Addendum # 1 Bid Opportunity: 25-7630-RFT - Laurentian Public School HVAC and Building Controls Upgrade Closing Date: Monday, February 18, 2025 2:00 PM

WRDSB-Laurentian PS-Phase 1 HVAC and Building Controls Upgrade WRDSB Project No.: 25-7630-RFT WF Project No.:2024-0789-11

ADDENDUM 01

1.0 Reference Reissued Drawing E103

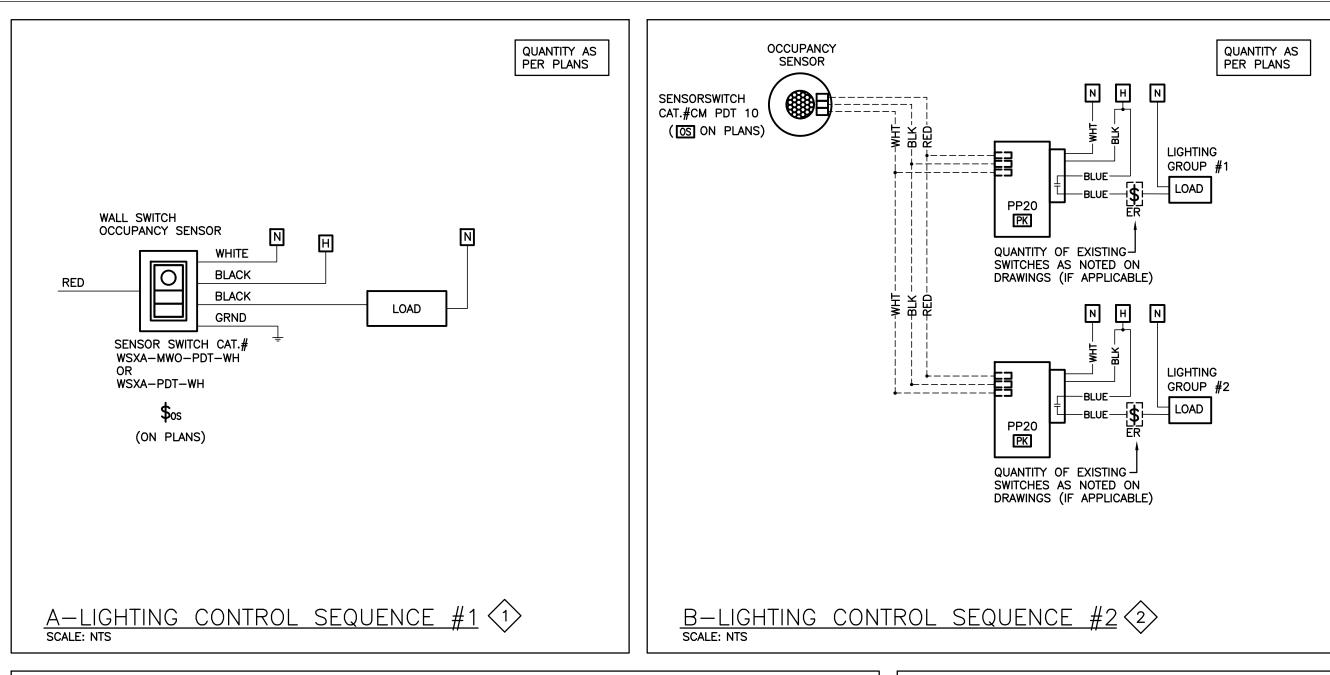
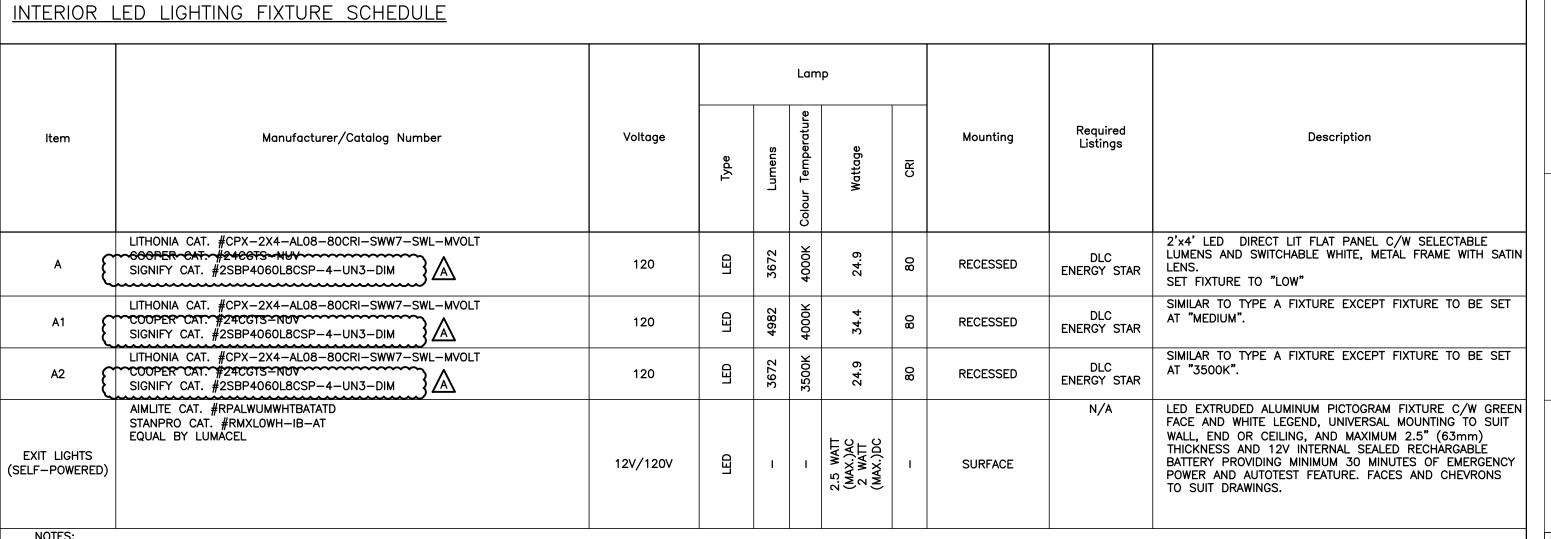
1 Provide Salex fixture alternatives within Interior LED Lighting Fixture Schedule as shown.
